ADDENDUM NUMBER ONE (1)

Project: "The Commons" Buildings
Hinds Community College – Rankin Campus
Pearl, MS
HCC Bid #3307
PN: 24053

FROM: Dean Architecture, P.A.
661 Sunnybrook Road, Suite 140
Ridgeland, MS 39157
(601) 939-7717

Sheet Number:
LS101
RESIDENCE HALL
LIFE SAFETY PLAN

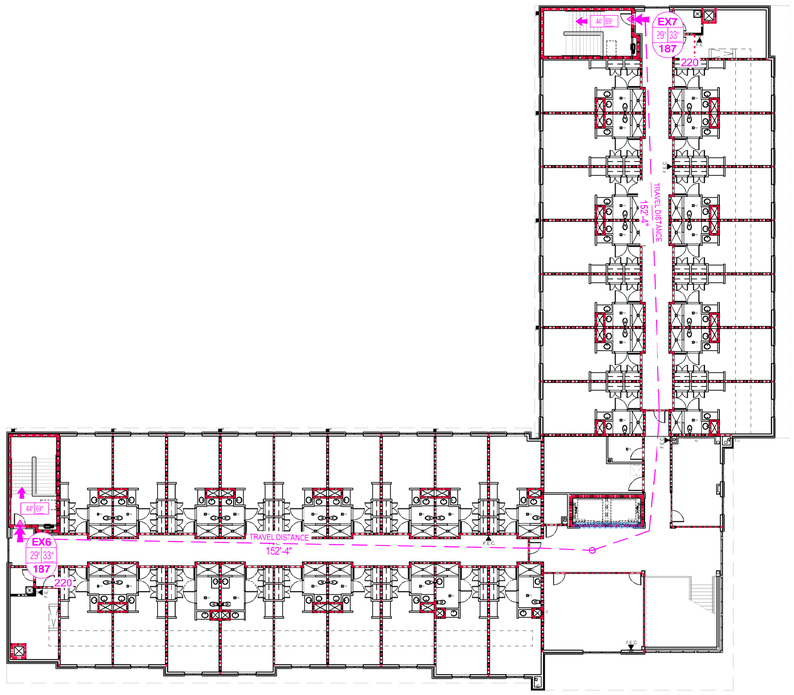
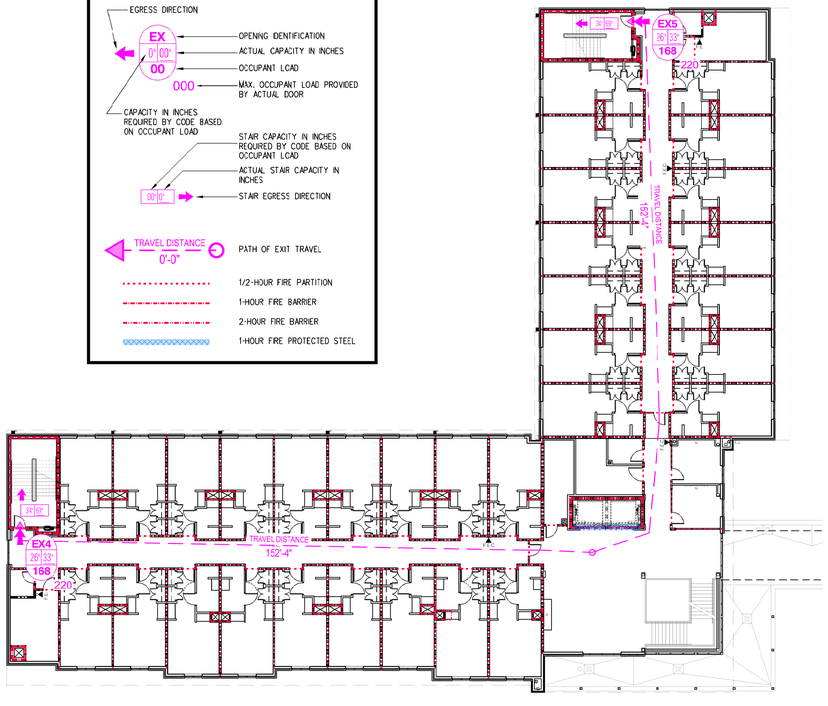
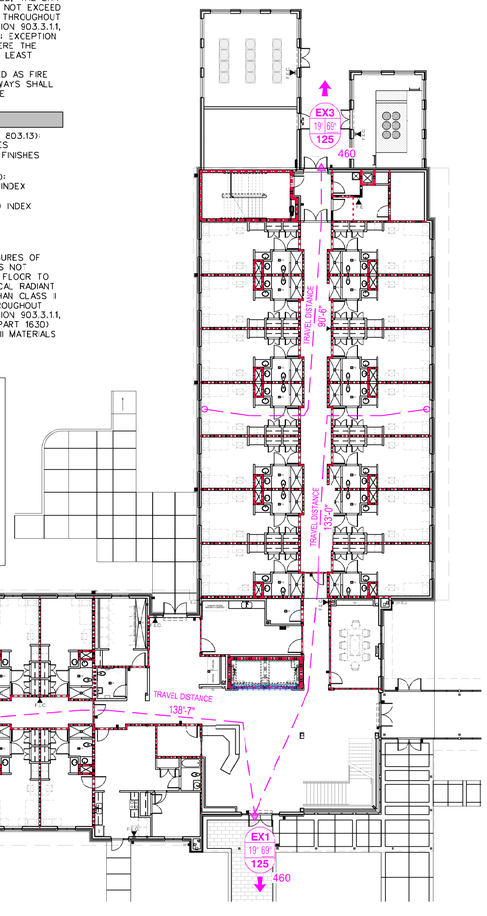
ITEM #1: SHEET LS101 – RESIDENCE HALL LIFE SAFETY PLAN.
Remove the existing sheet and replace it with the revised sheet dated 9/30/2025. Added State Fire Marshall 2024 IBC Code requirements.

Sheet Number:
LS102
DINING HALL
LIFE SAFETY PLAN

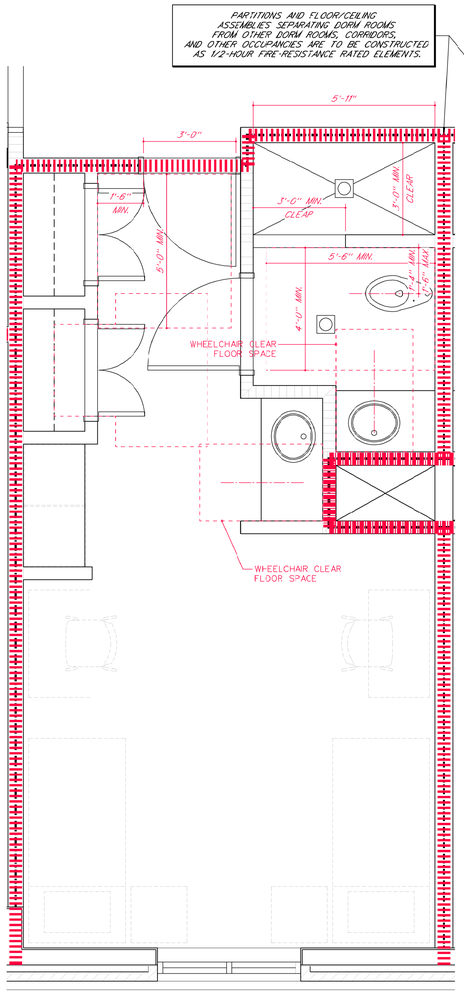
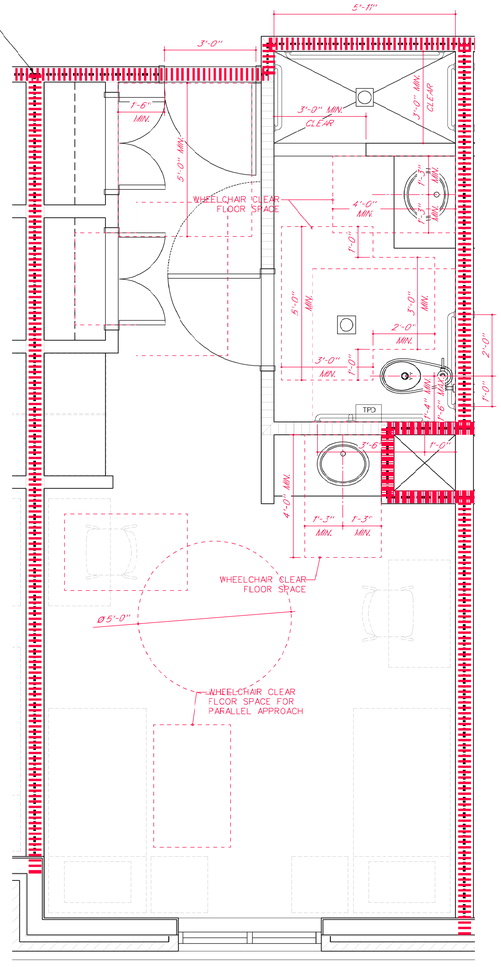
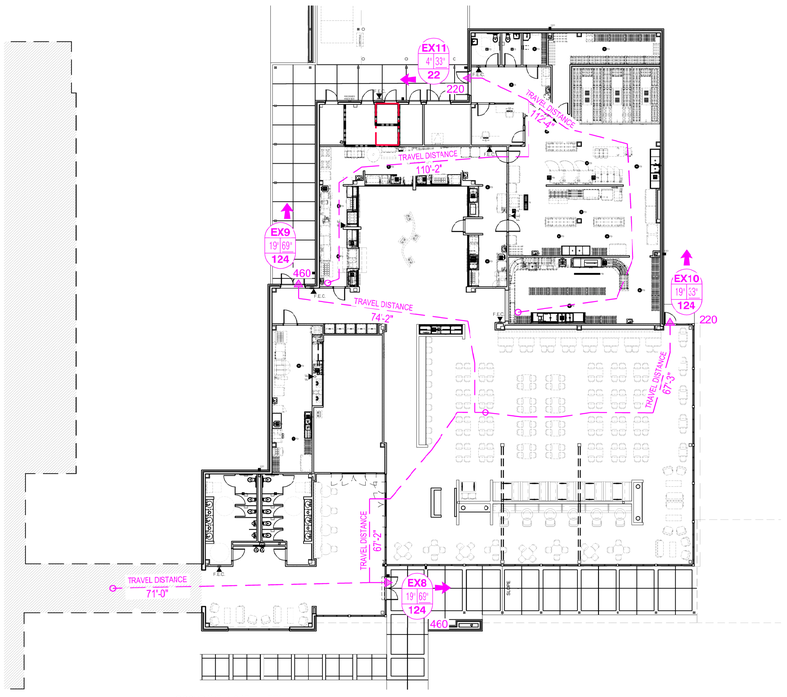
ITEM #2: SHEET LS102 – DINING HALL LIFE SAFETY PLAN.
Remove the existing sheet and replace it with the revised sheet dated 9/30/2025. Added State Fire Marshall 2024 IBC Code requirements.

Sheet Number:
A104
RESIDENCE HALL FIRST FLOOR RCP

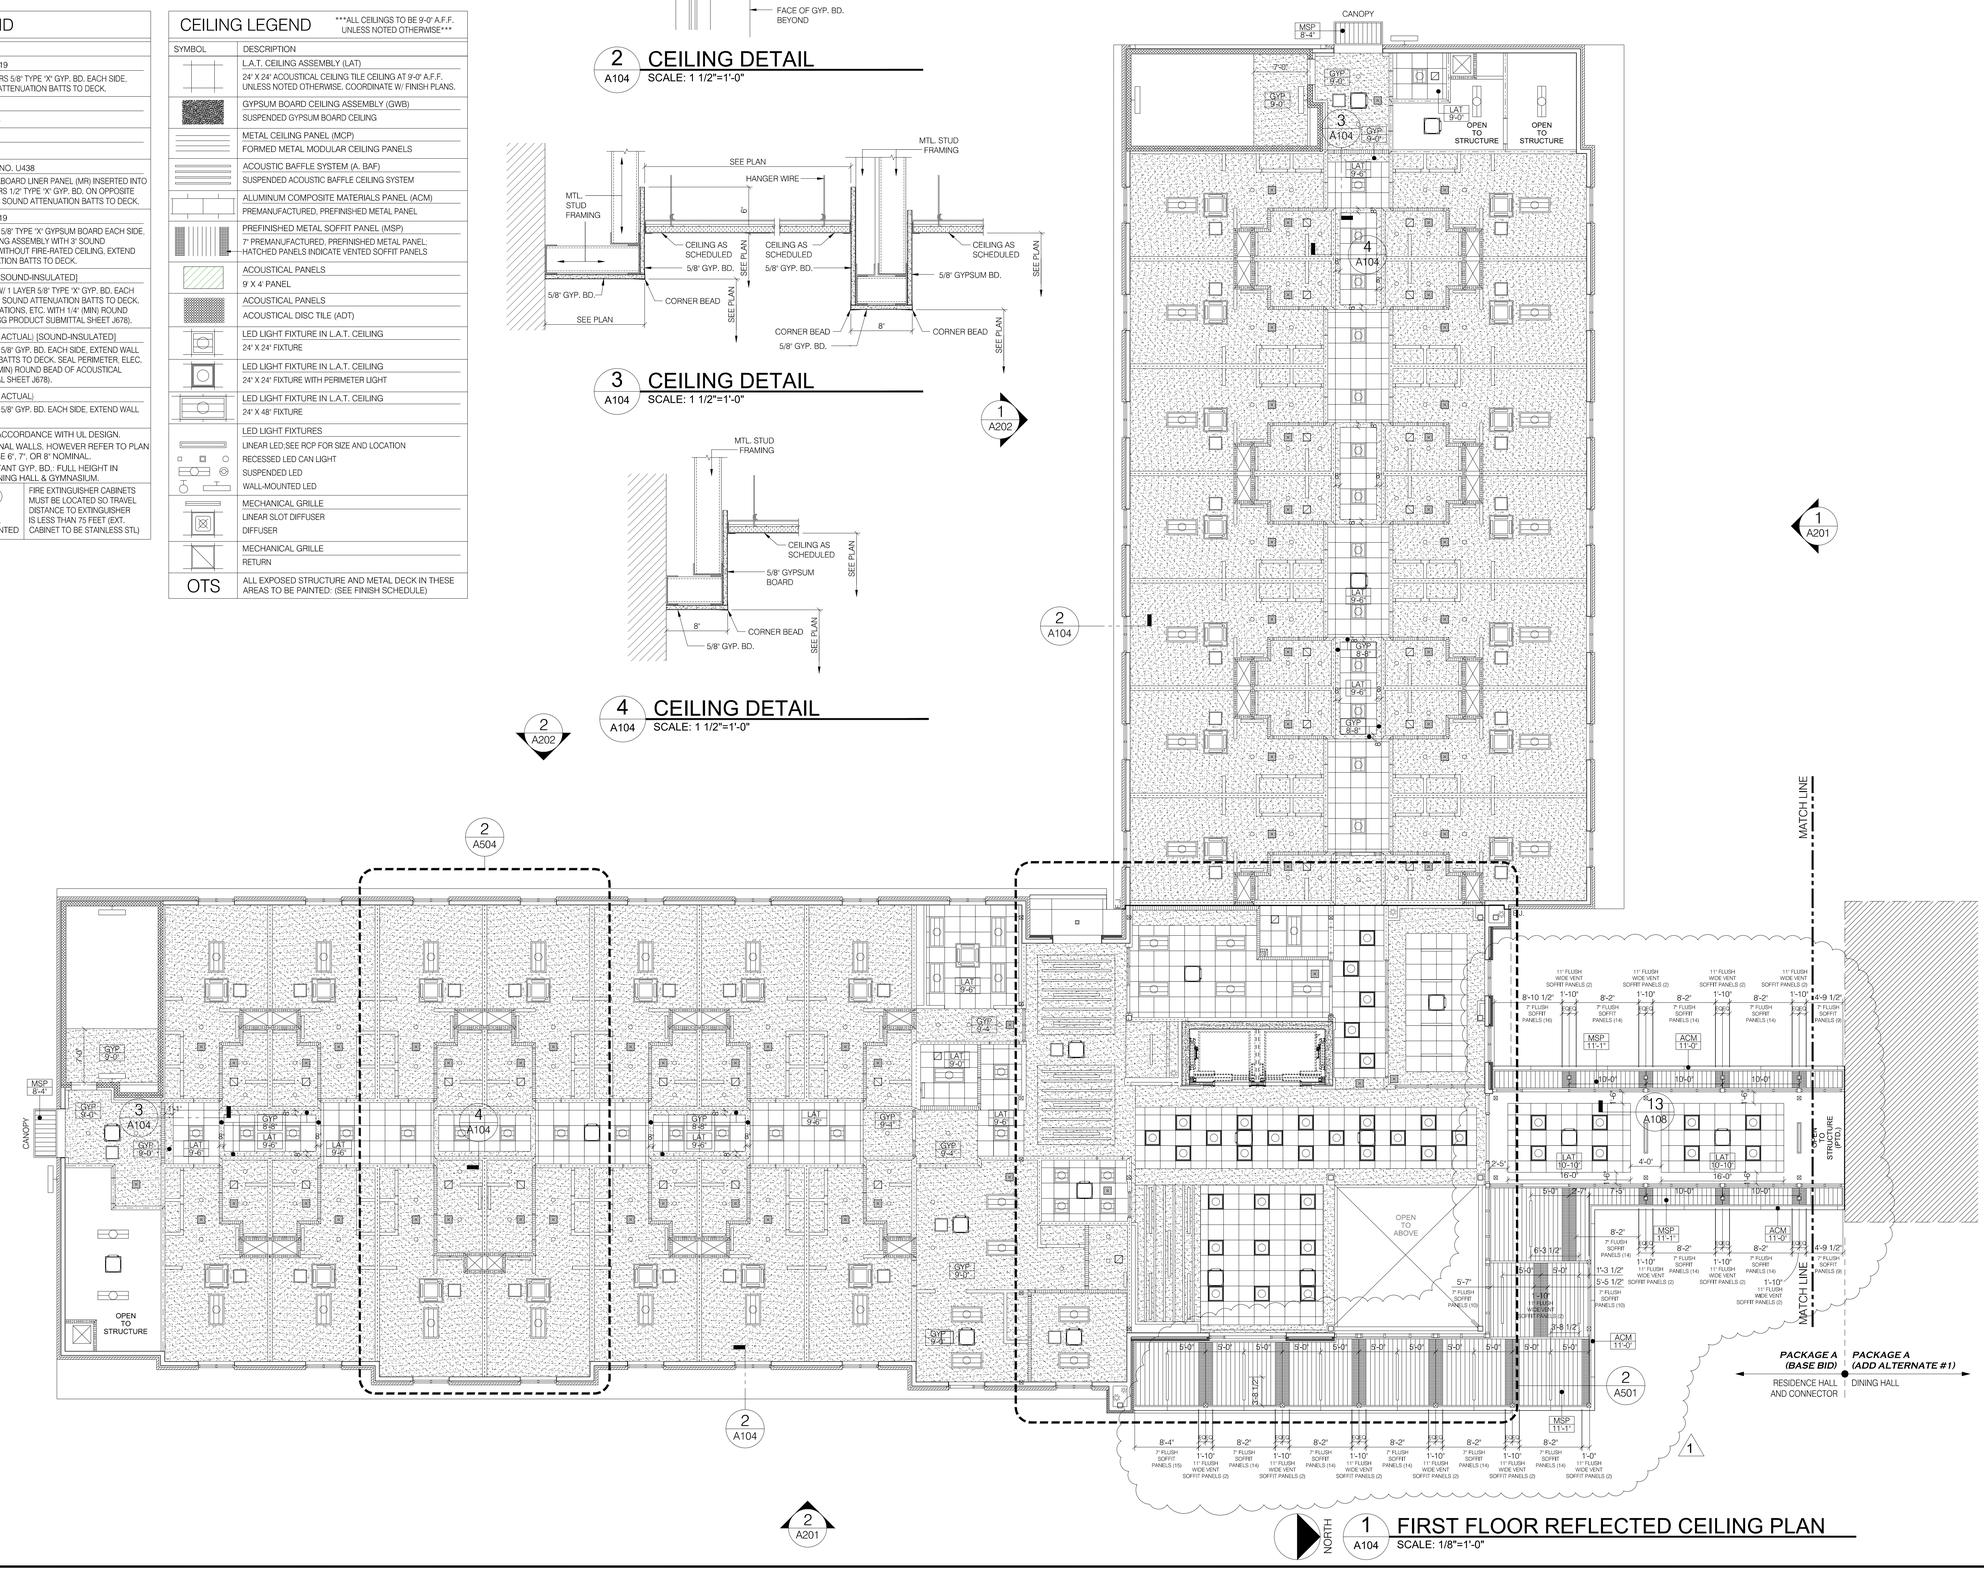
ITEM #3: SHEET A104 – RESIDENCE HALL 1ST FLOOR R.C.P.
Remove Existing sheet and replace with revised sheet dated 9/30/2025 – Dimension Clarification on soffit lights.

RESIDENCE HALL ROOF PLAN

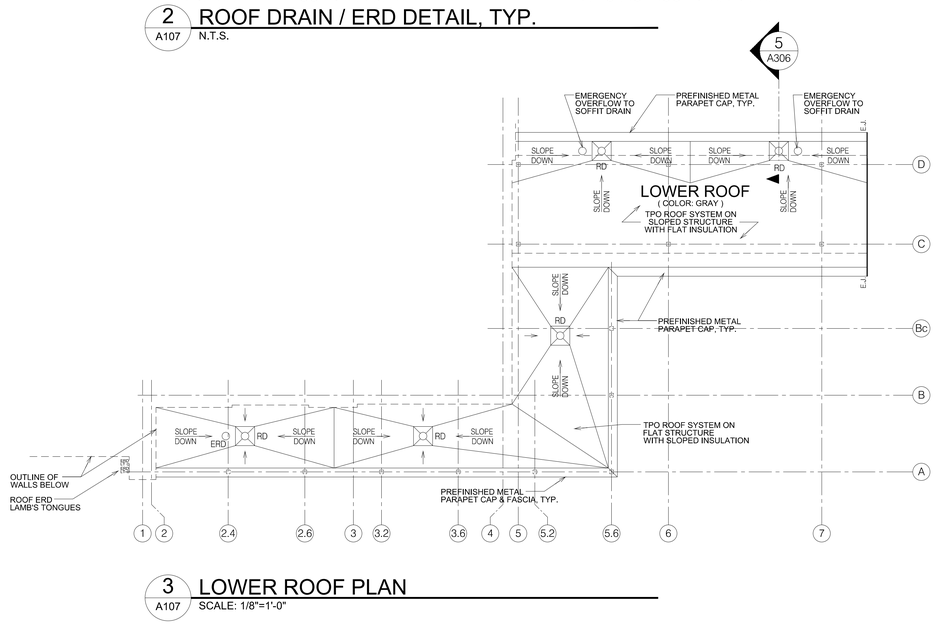
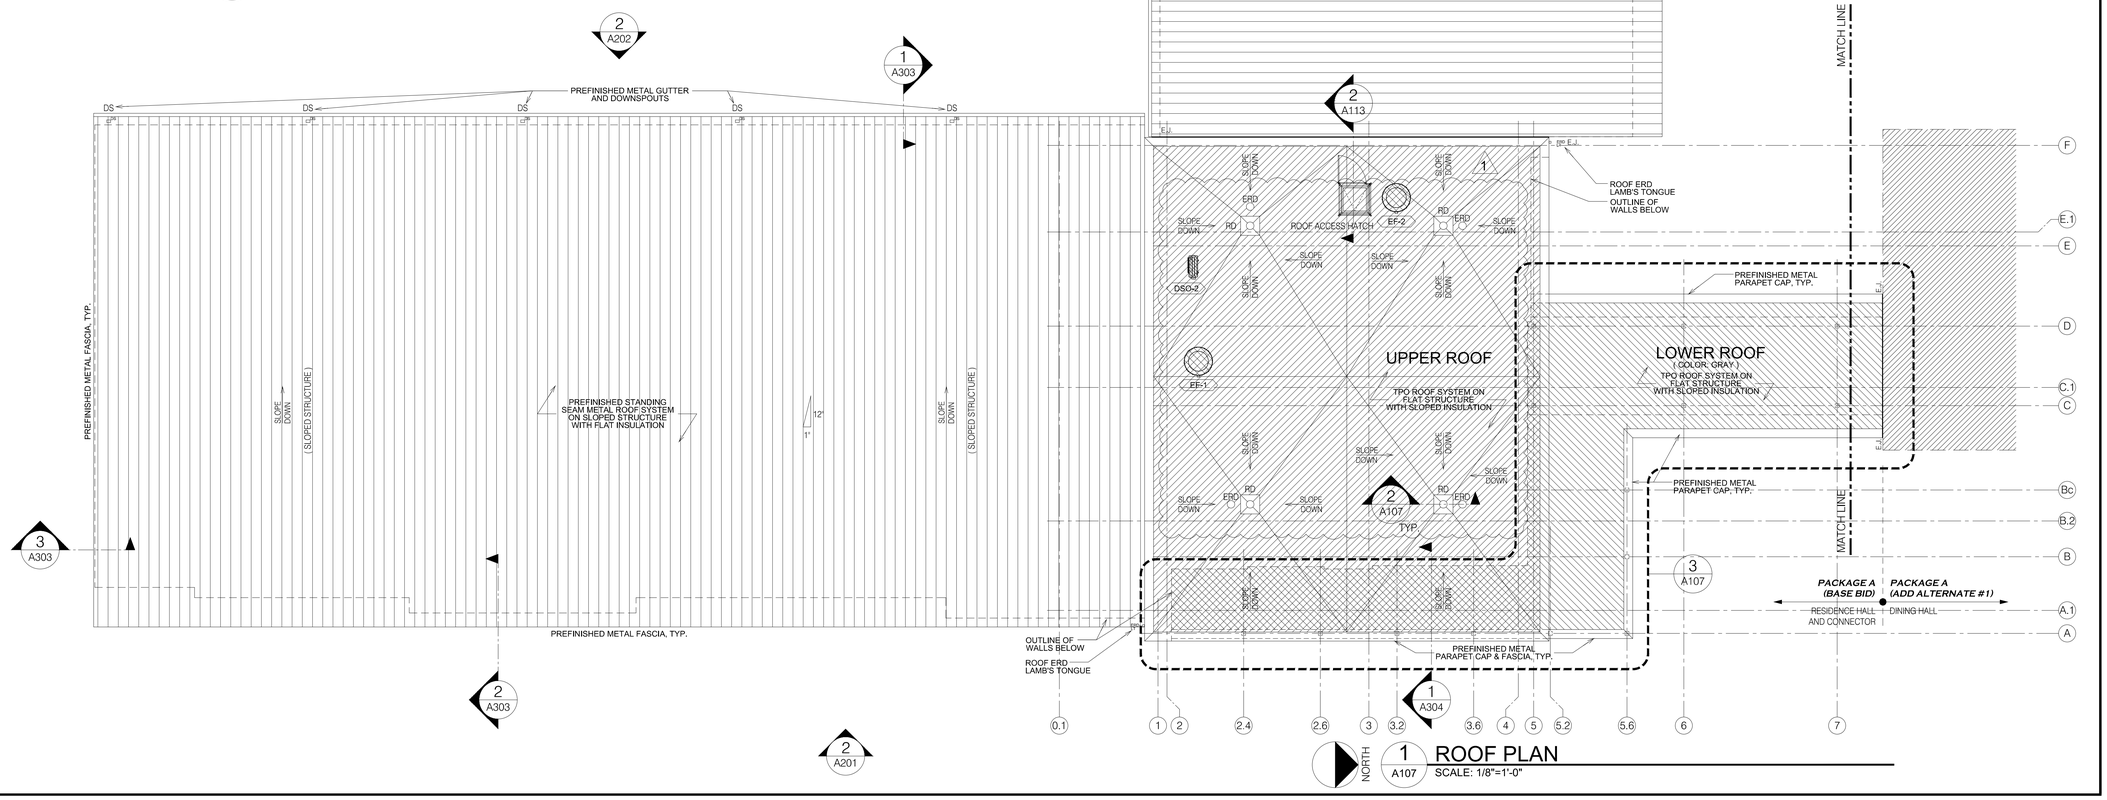
ITEM #4: SHEET A107 – RESIDENCE HALL ROOF PLAN.
Remove existing sheet and replace with revised sheet dated 9/30/2025 – Added condenser unit to roof plan.
